Ref: Case 15zone1070

TRAFFIC AND ROAD SYSTEM
ANALYSIS

CASE 15ZONE1070

TRAFFIC
AND
SITE ACCESS STUDY
CASE 15ZONE1070
MARCH 1, 2016

EASTBOUND TRAFFIC BACKUP ON BROWNSBORO RD
AT I-265 RAMPS VIEWED FROM SIMCOE LN

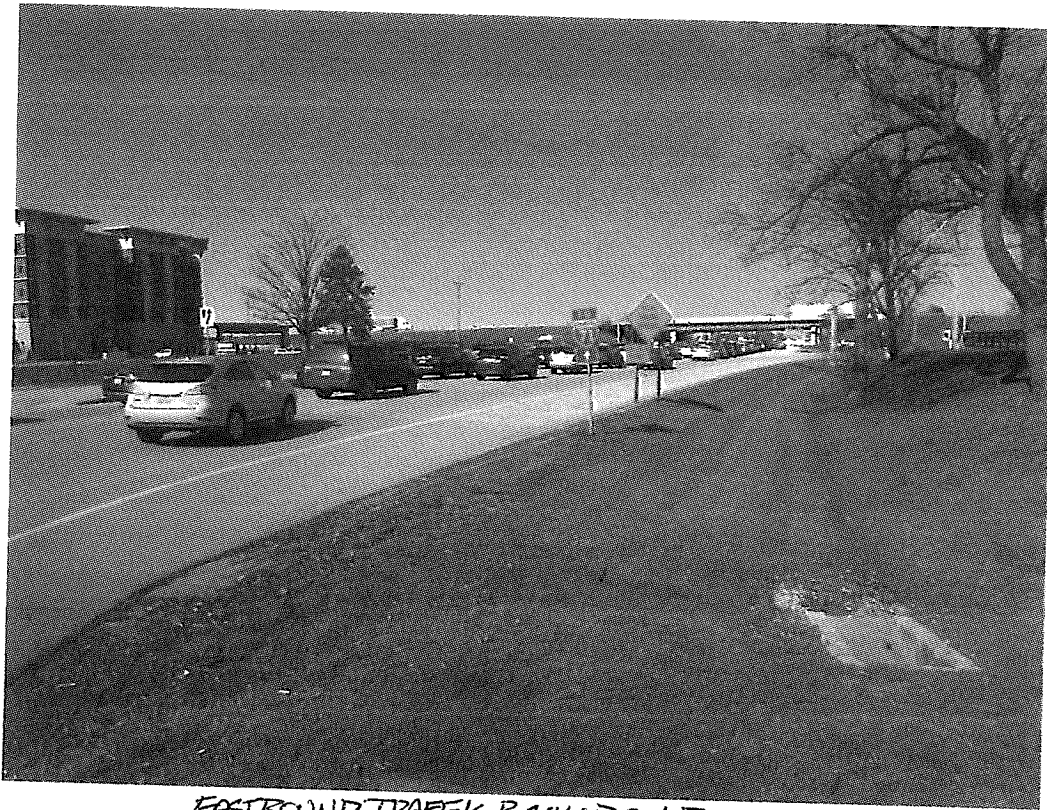
First, there is a traffic light on Brownsboro Rd. just a few hundred feet east of Simcoe Lane that controls ramps to and from I-265 as well as Brownsboro Rd. When the light is red for eastbound traffic on Brownsboro Rd., traffic backs up through the Simcoe Lane intersection, blocking left turns from Brownsboro Rd. That left turn lane is only 300 ft long, not 350 ft as reported by Ms. Zimmerman to Ms Markert. Once traffic growth is more accurately projected it is likely that the turn lane will not be sufficient to accommodate vehicles needing to turn into Simcoe Lane, cars will be backed up into the inside traffic lane and delays will be substantial. See attached photos.

Exhibit 2a Evergreen trees location and spacing

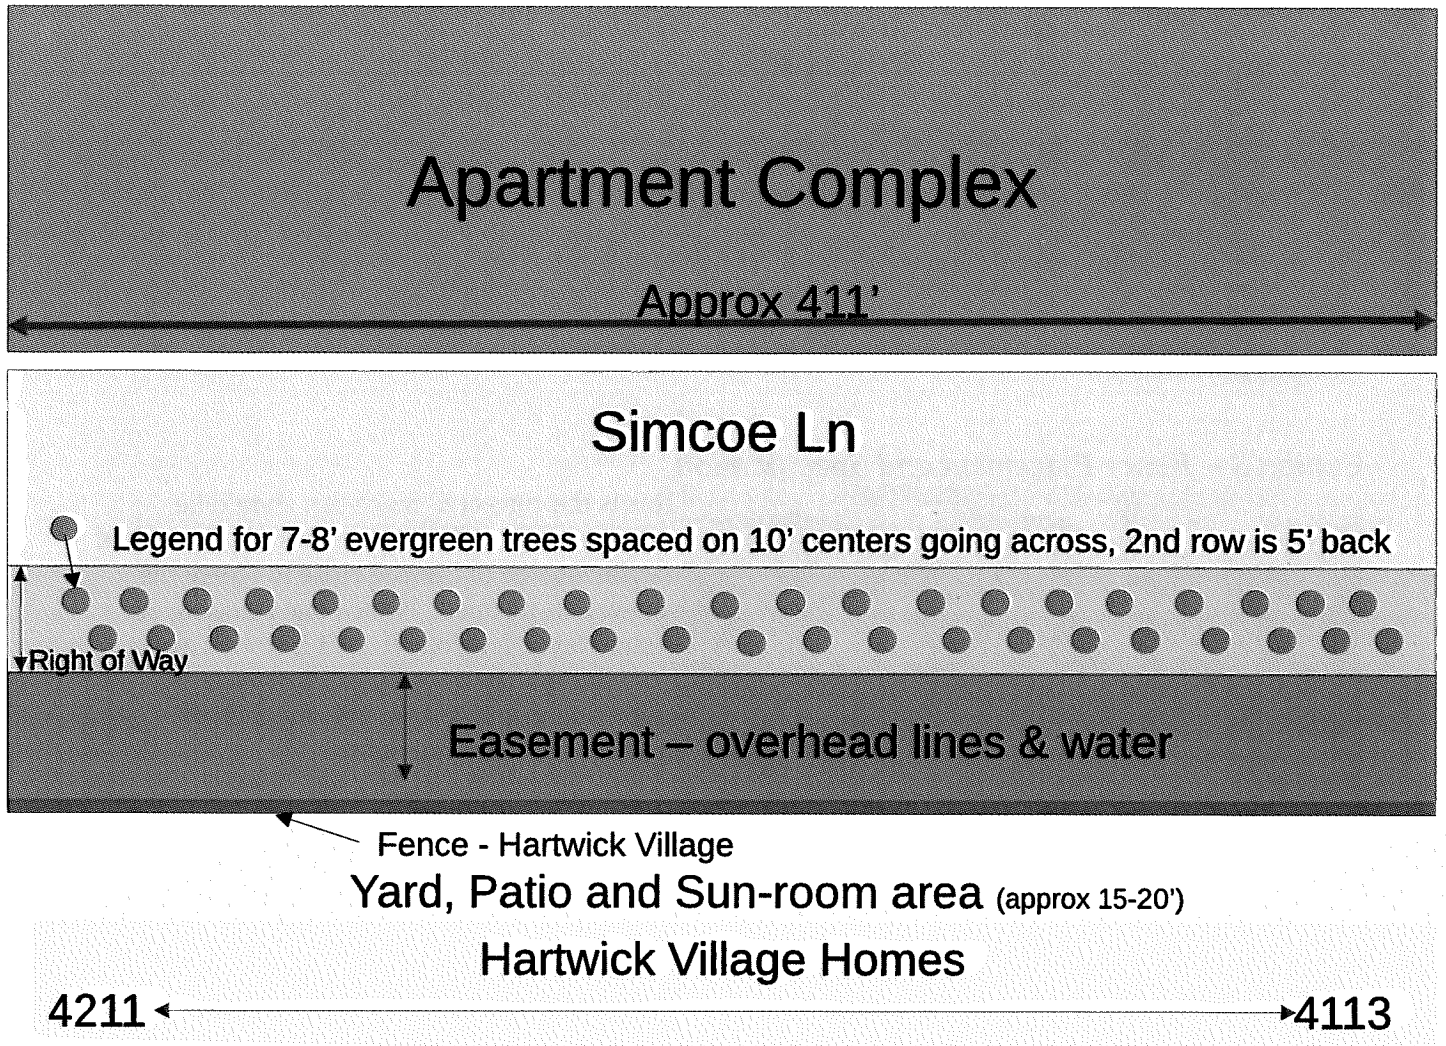
We met with Sherie Long and Erin Thompson from Planning and Design services on 2/19/16 and developed the following plan. The developer will plant a row of 7-8' evergreen trees or similar pines planted 10' off of Simcoe on 10' centers and a second row of 7-8' evergreen trees staggered behind the first on 10' centers (*see exhibit 2a*). These will be planted on the west side of Simcoe Ln (*exhibit 1*) the entire width of of the new development (approx 411') This will require the removal of 13 scrub trees (*see exhibit 2b*). The overhead lines have been considered and this plan will not interfere with them. As the trees mature and grow they will provide a sound barrier from the additional traffic as well as raising the line of sight higher from the balconies and windows of the apartment residents across the street. We confirmed with Peggy Heustis (horticulturist) of Greenscapes that this is a good plan and the trees are compatible with the growing conditions for this area.

Exhibit 1 Line of Sight

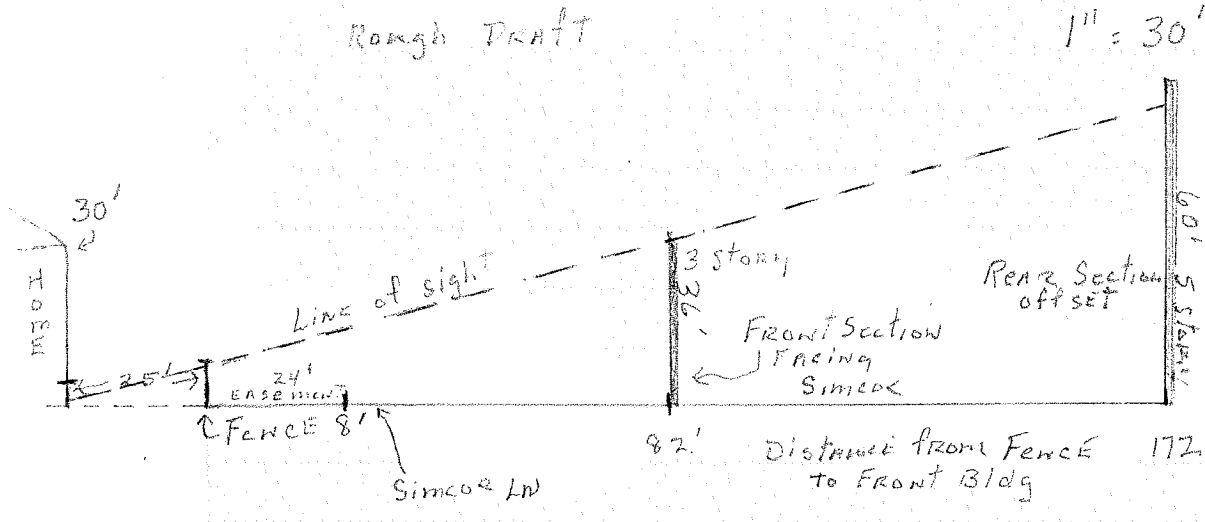
As this rough diagram illustrates those residents above the 2nd floor will have a direct line of sight view into the back yards, patios, sun-rooms and lower windows of the home in Hartwick.
